HUTT RIVER - PEER REVIEW AUDIT
AUGUST 2006

1. Introduction

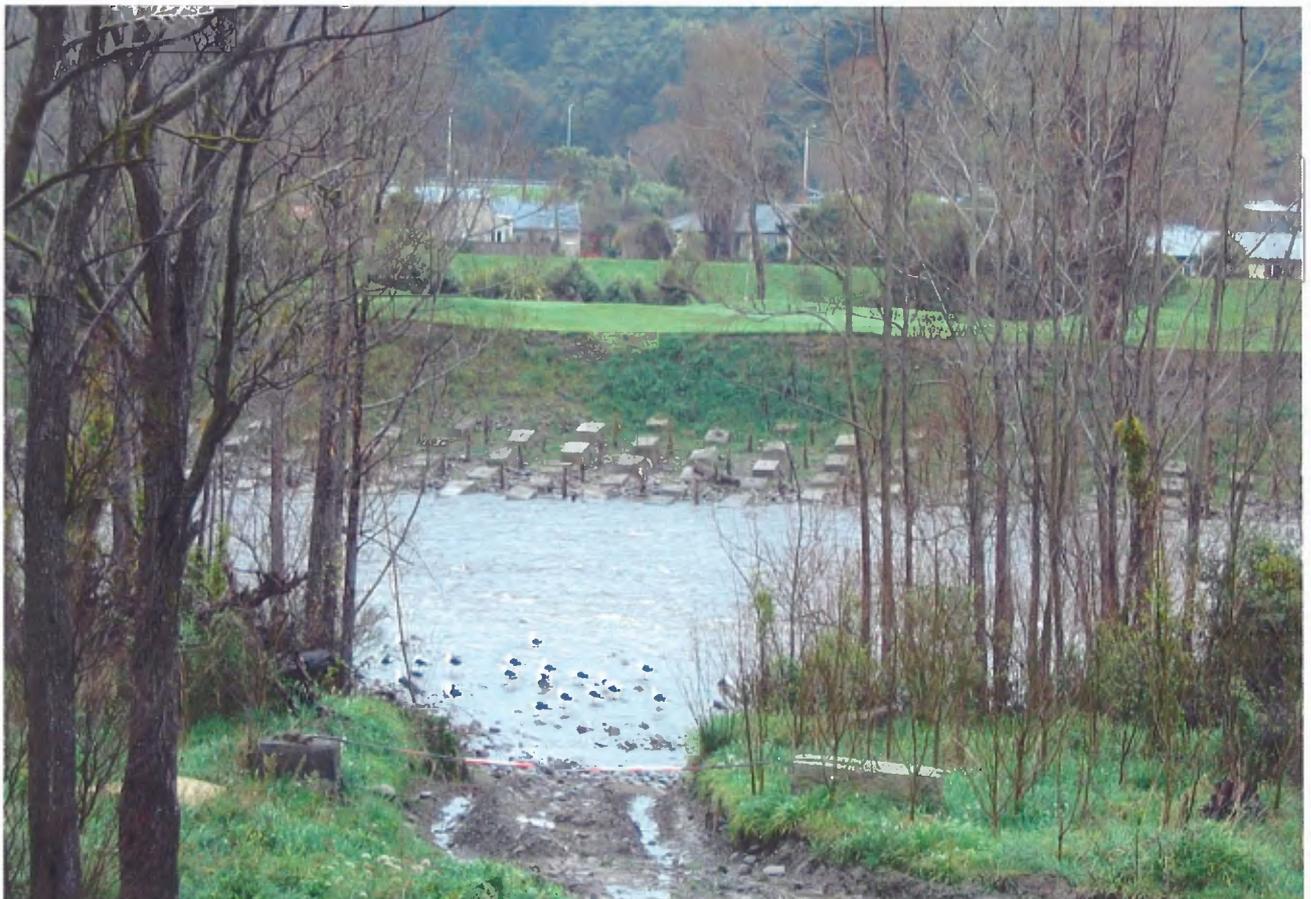
The review team had no comment to add on this operation, but were happy to see some site beautification taking place in the form of bank planting and general site tidiness.
